**RE: Paseo del Norte Sports Complex, Tract A, Loop Industrial Park
Grading and Drainage Plan
Engineer's Stamp Date 6-11-2015 (File: C17-D008)**

Re: Paseo Del Norte Sportsplex, Hydrology Re-Submittal

date
6-10-15
sheet
c001

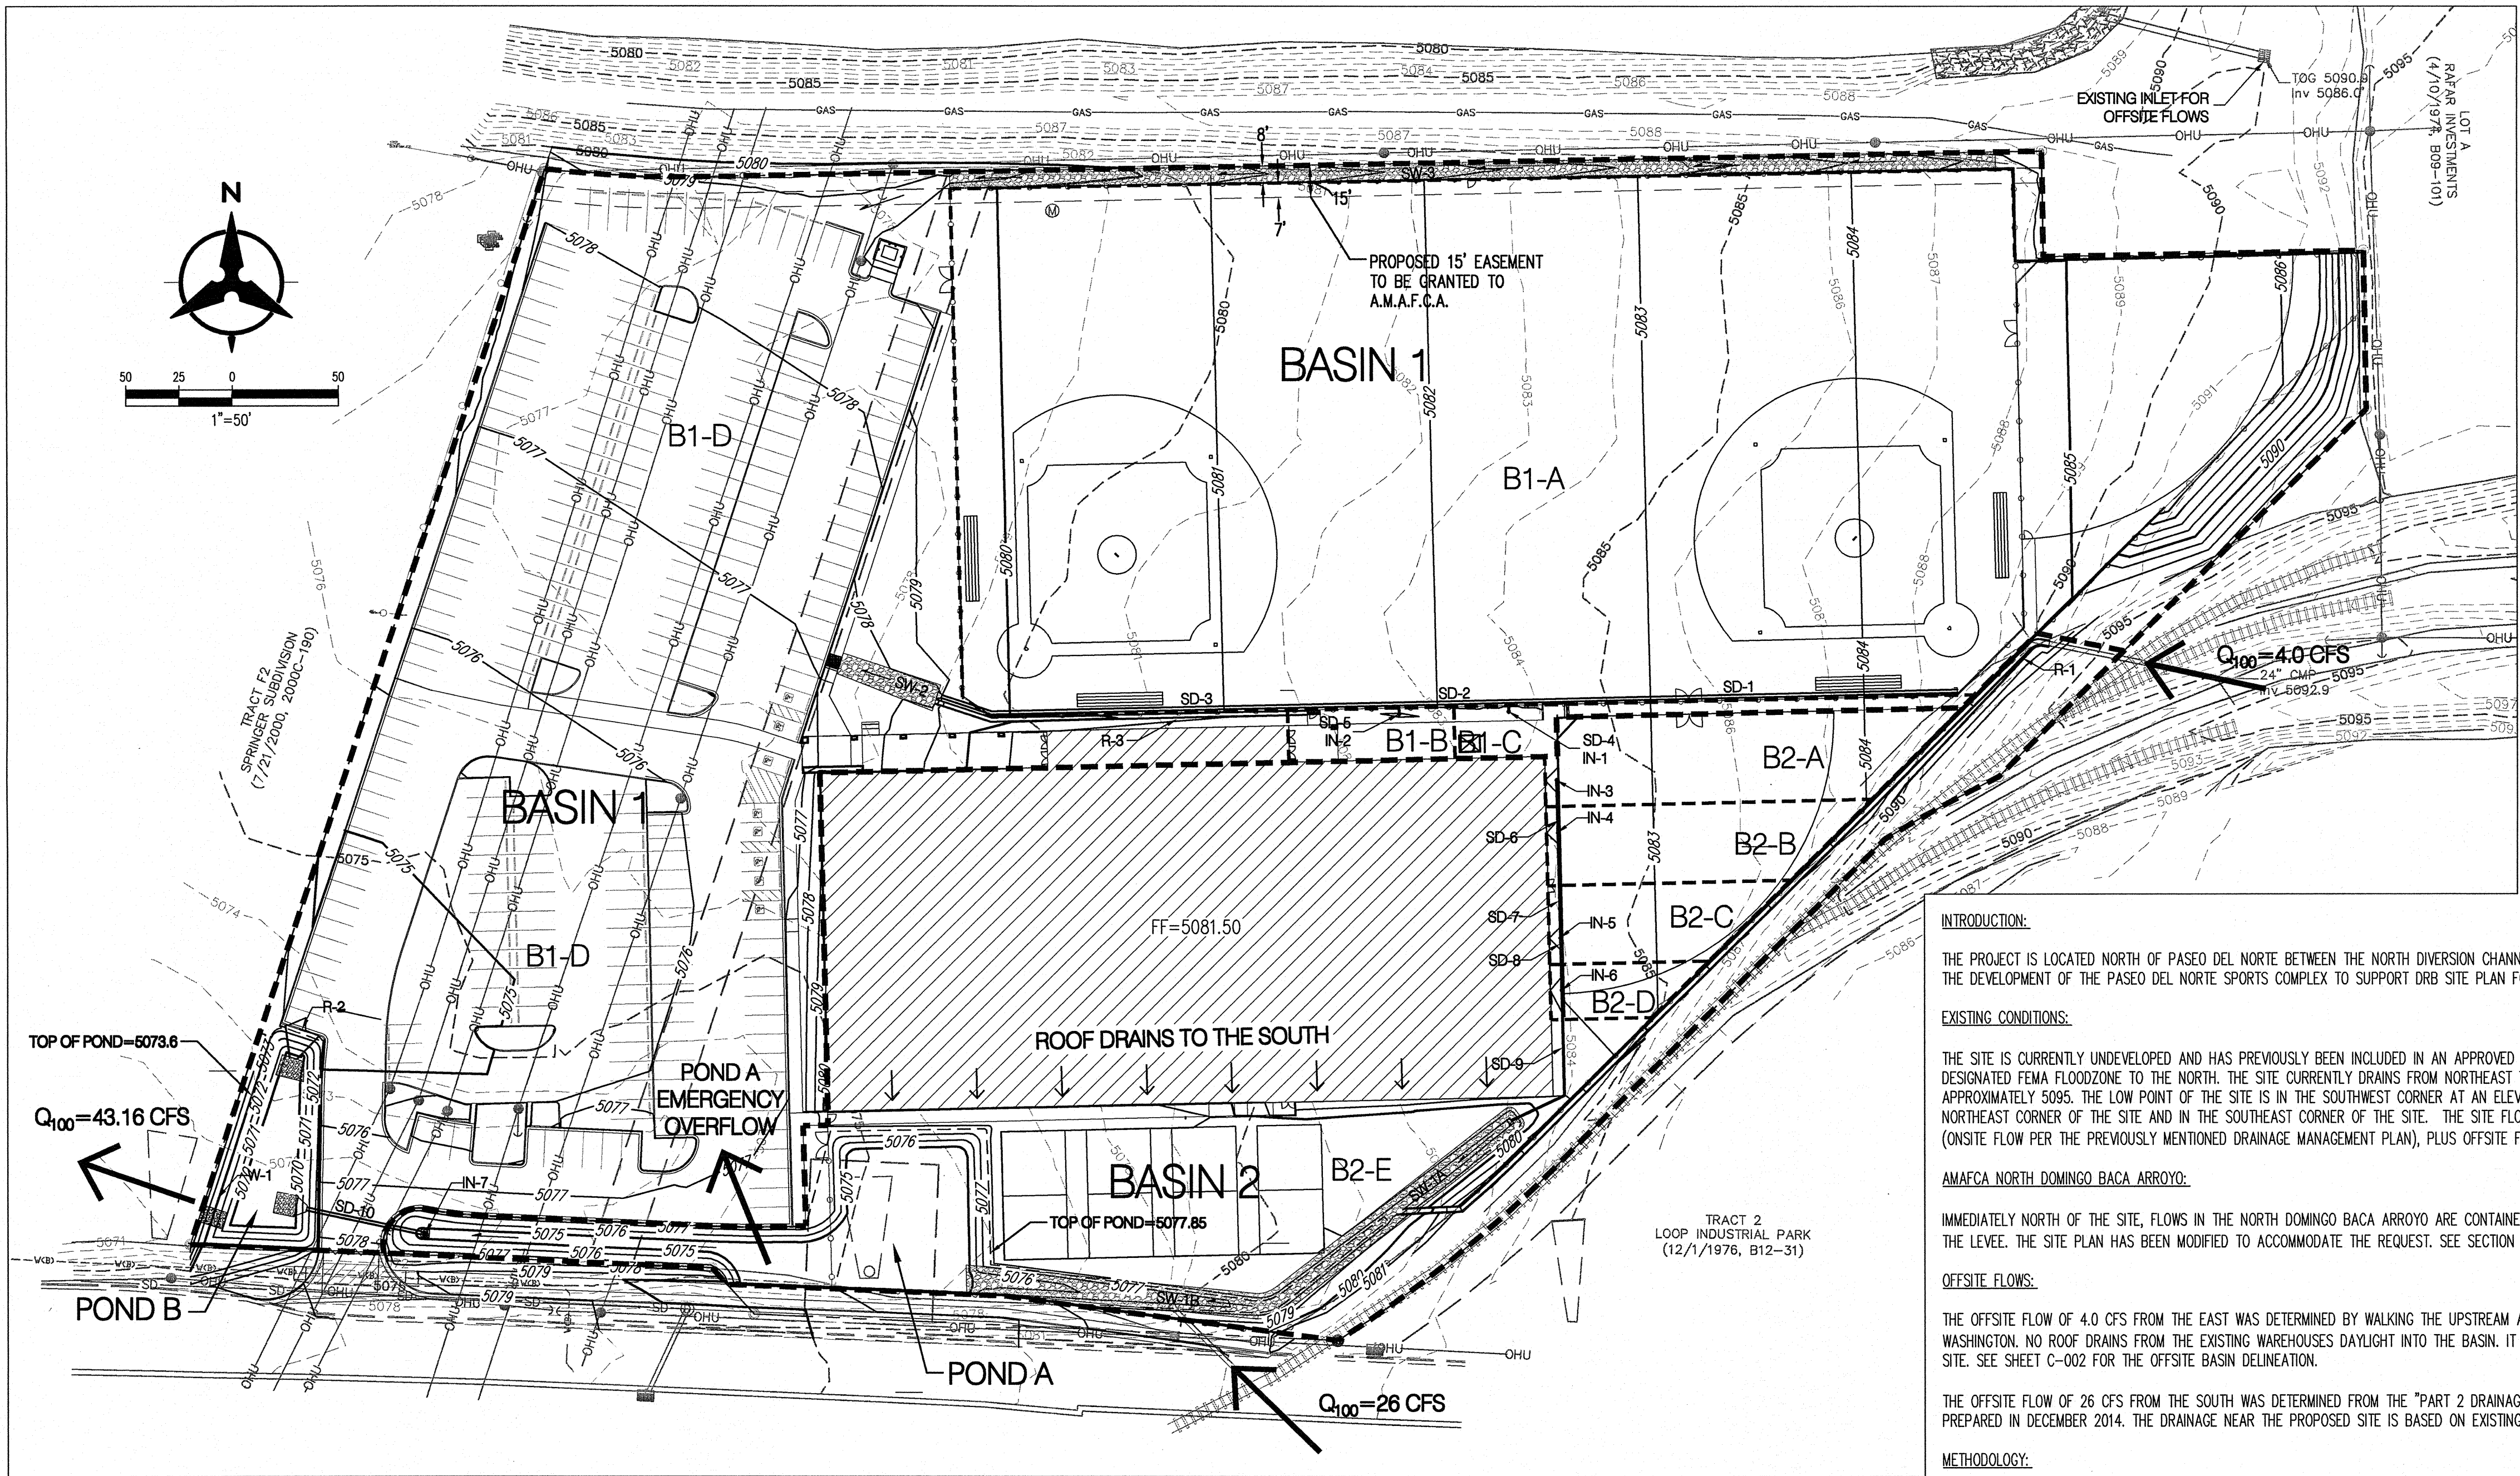
3. A few additional spot elevations have been provided on the Grading Plan for clarity. A "Top of Pond" boundary (shown as a dashed line) for Pond "A" and Pond "B" has been provided on the Drainage Management Plan (C-001).

The runoff from the building drains entirely to the South. More information showing the direction the roof drains has been provided on the Drainage Management Plan (sheet C-001).

M RIP-RAP BLANKET DETAIL
N.T.S.

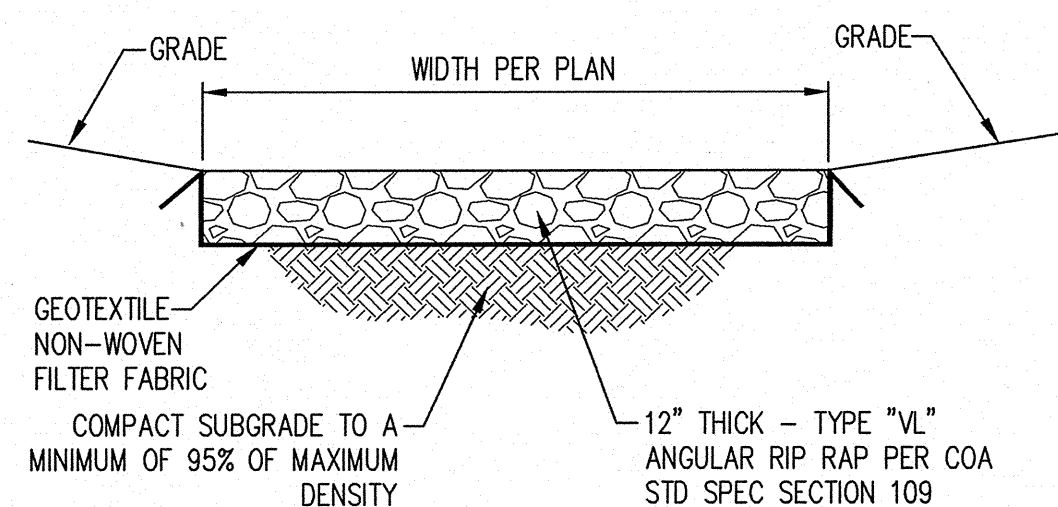
8. Type "VL" Angular Riprap per COA Standard Specification 109 has a mean particle size of 6". The Riprap details on sheet C-102 have been updated to reference a 12" thickness which is 2.0 times the aforementioned mean particle size of 6".

P 16' RUNDOWN DETAIL
N.T.S.

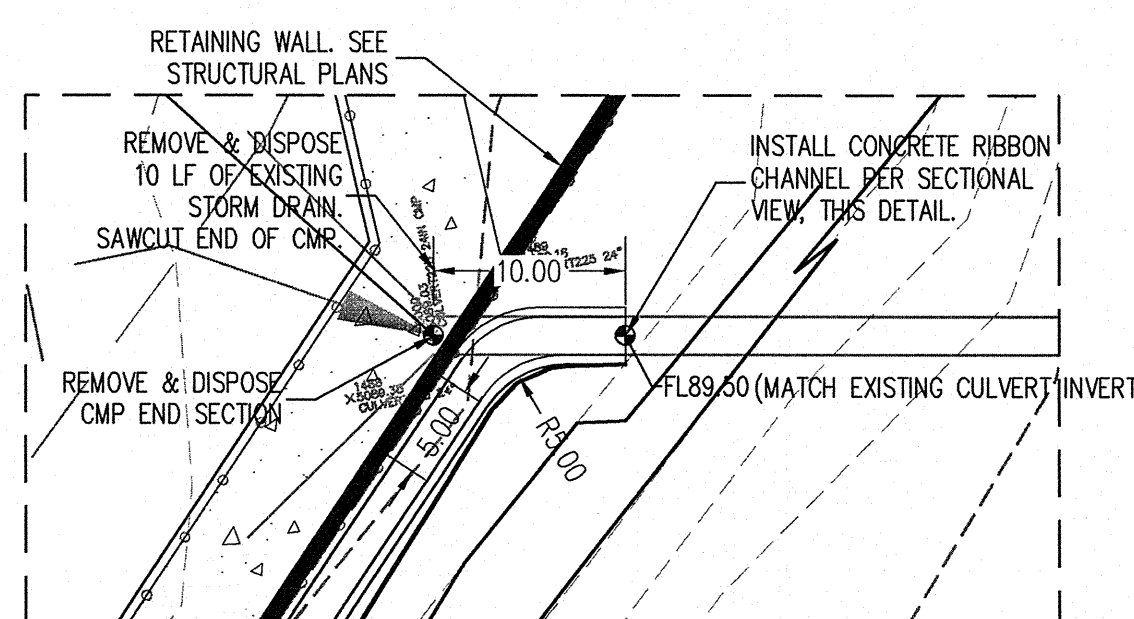
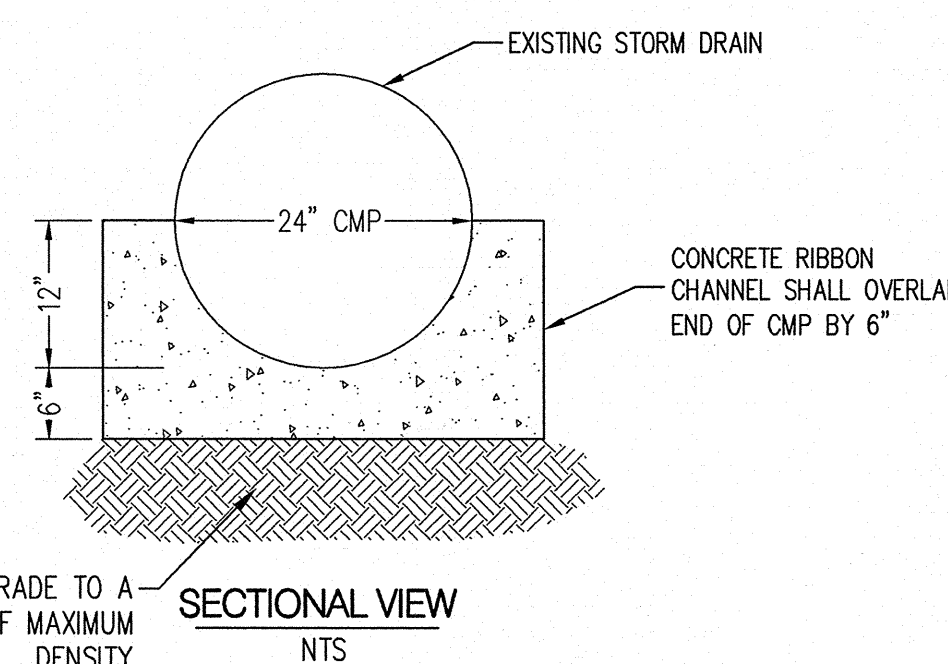
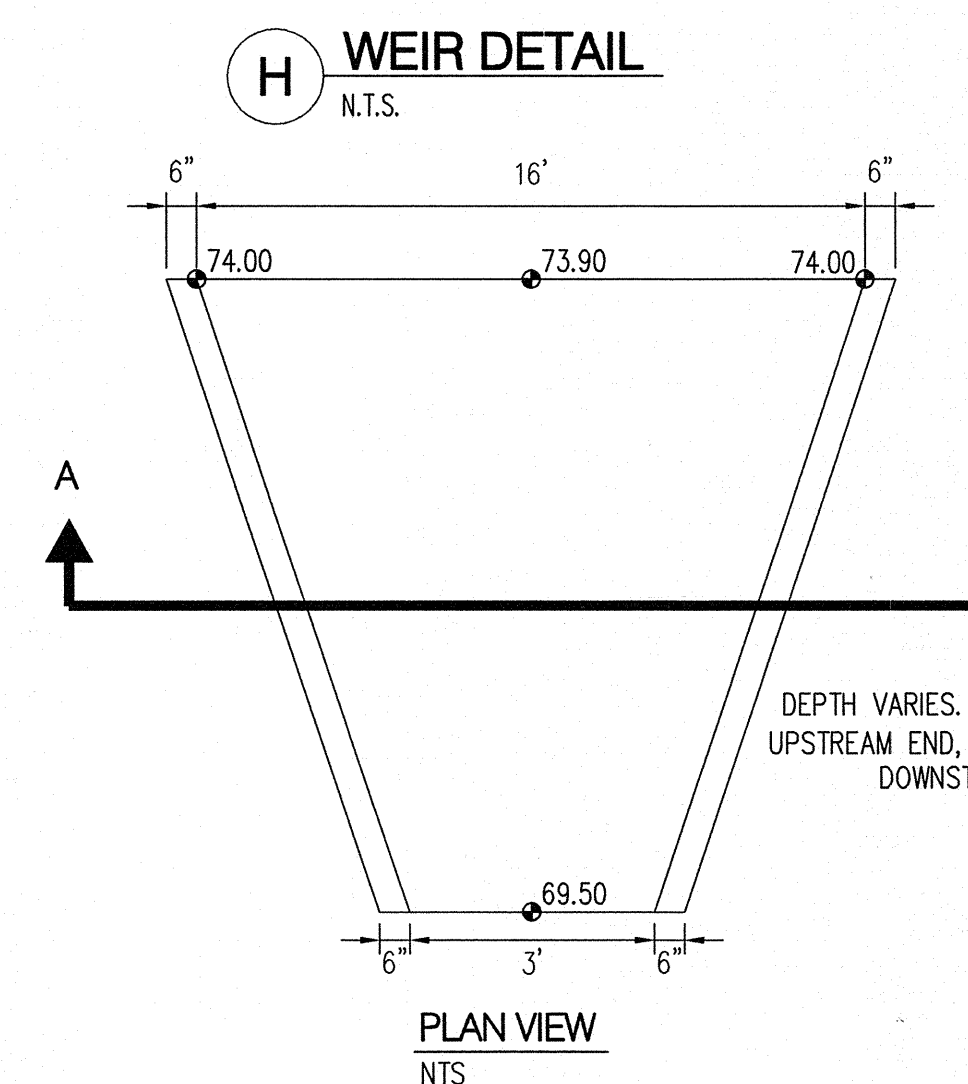
7. A new detail for the large 16' concrete rundown has been provided on sheet C-102. All rundowns are now referenced by the same designation.

ENGINEER'S SEAL	DATE	DRAWN BY
DAVID SOULE P.E. #14522	1-27-05	WCWJ
PASEO SPORTS COMPLEX		DATE
GRADING AND DRAINAGE PLAN		2453-GRB-9-09-04X
Rio Grande Engineering		SHEET #
1806 CENTRAL AVENUE SE SUITE 201 ALBUQUERQUE, NM 87108 (505) 872-0399		JOB #
		2453

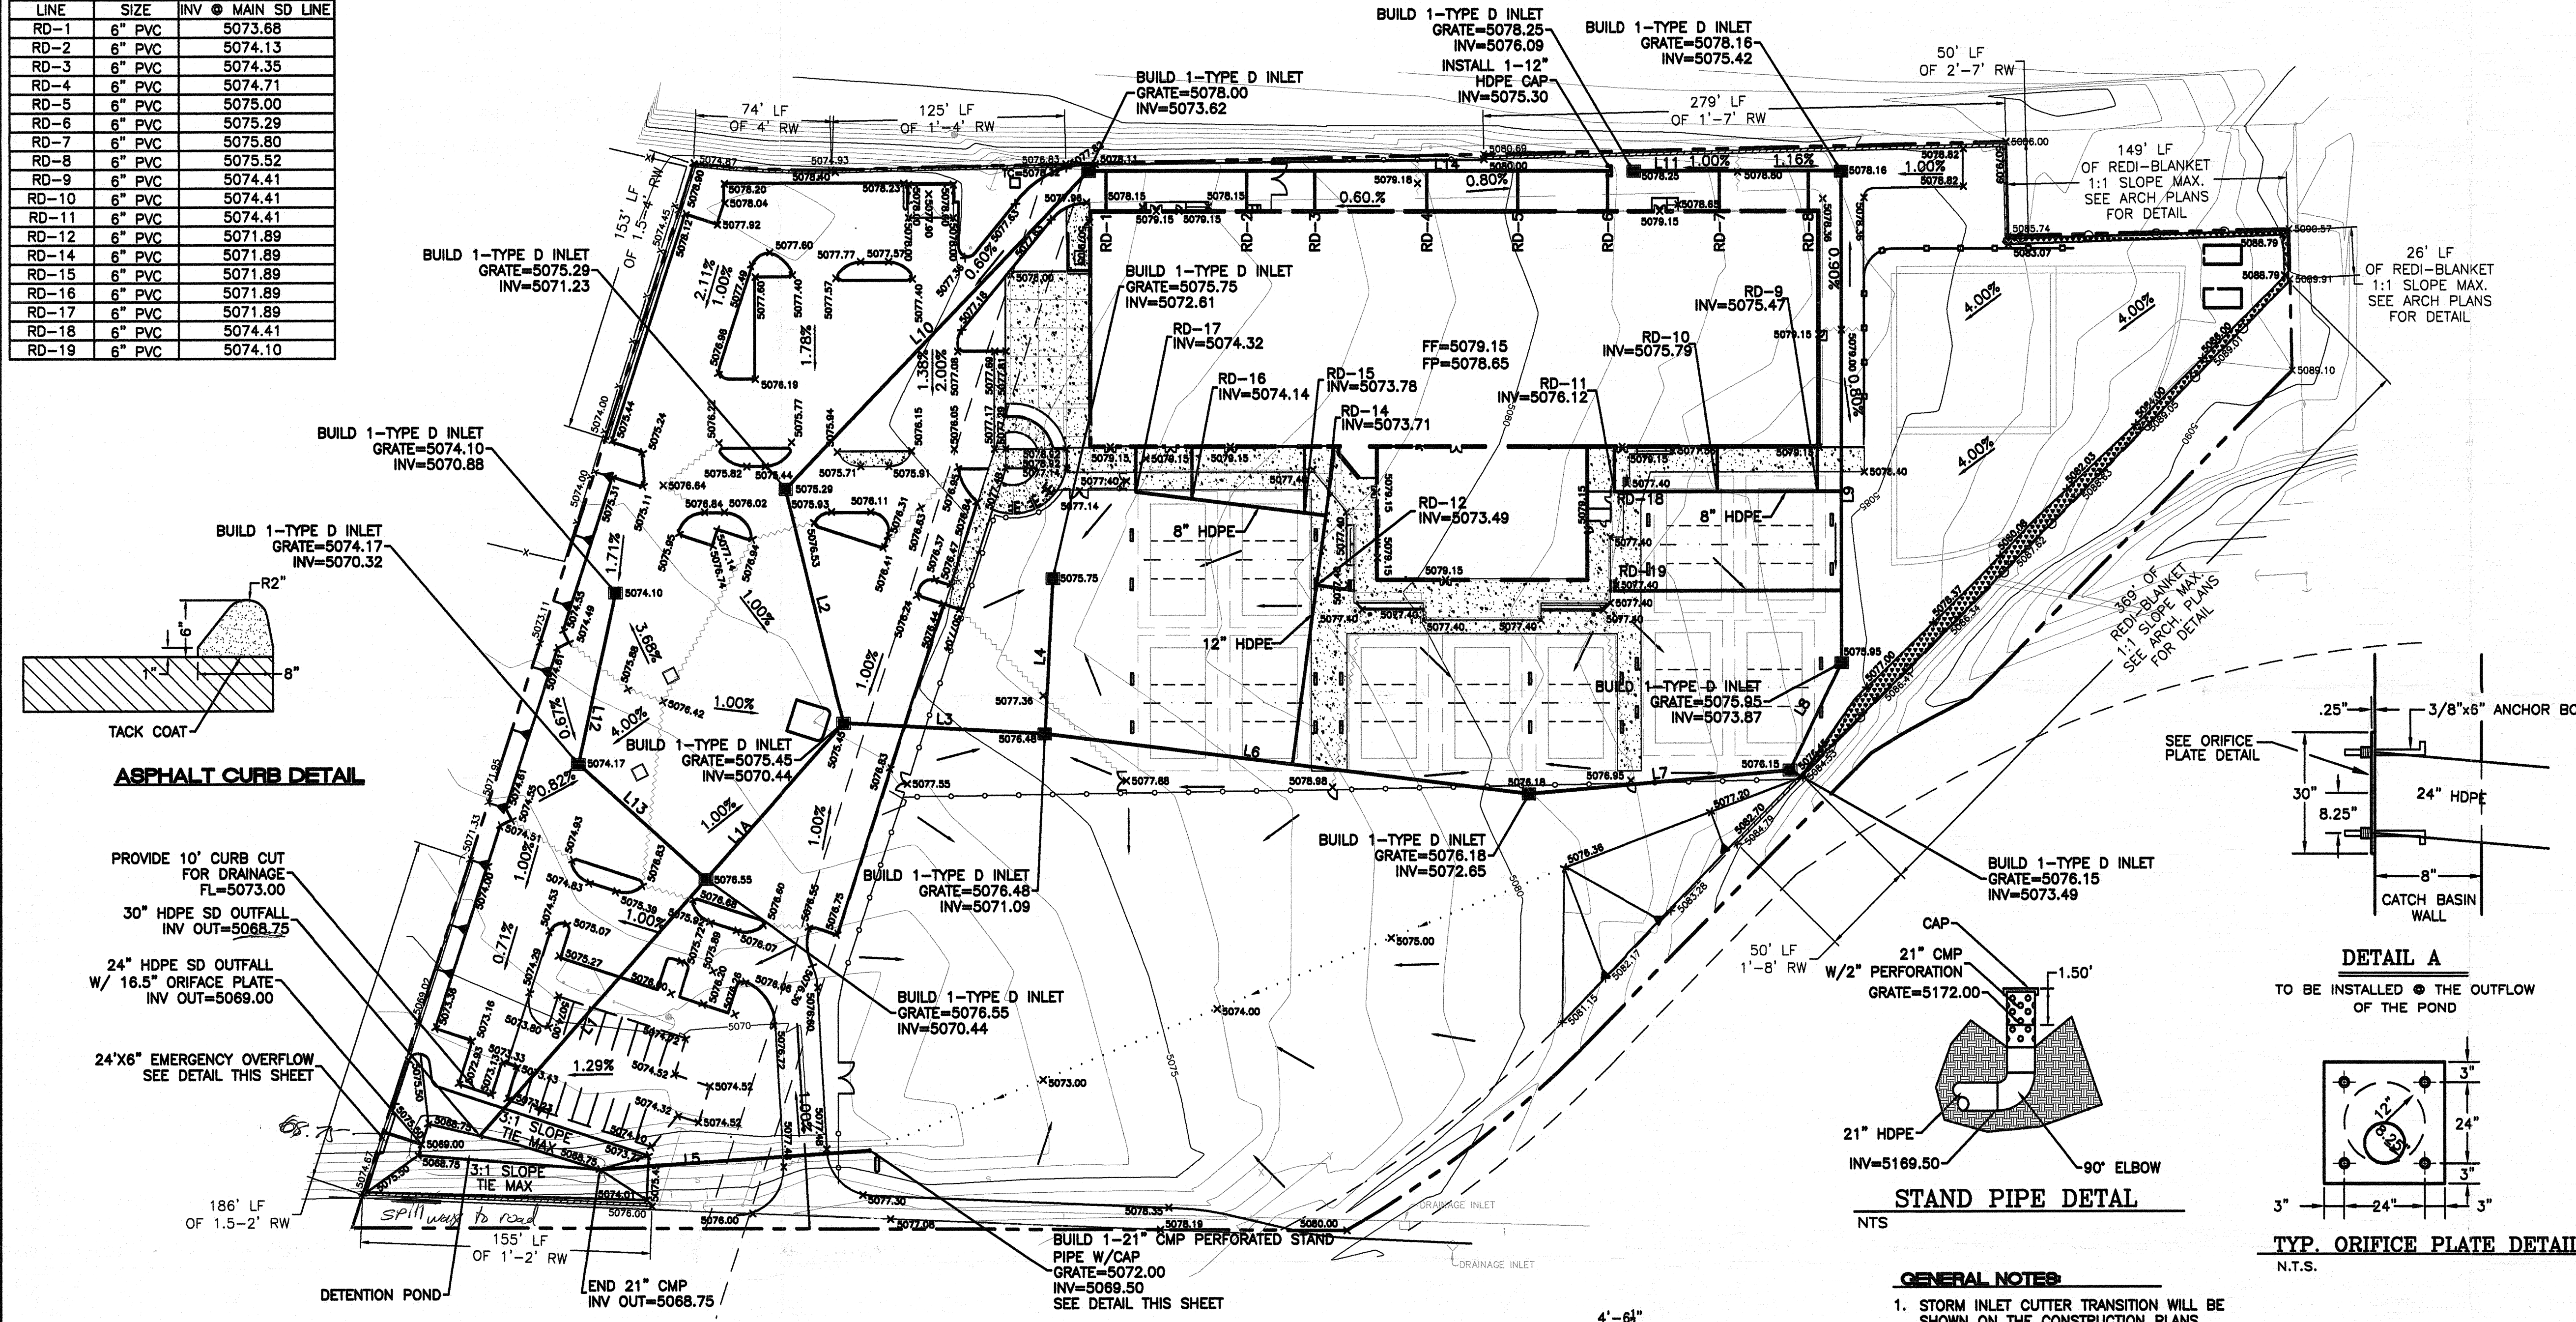
3. provide excpts from (C17-D19) denote allowable runoff
1. point spill to road
2. water get out of pond?
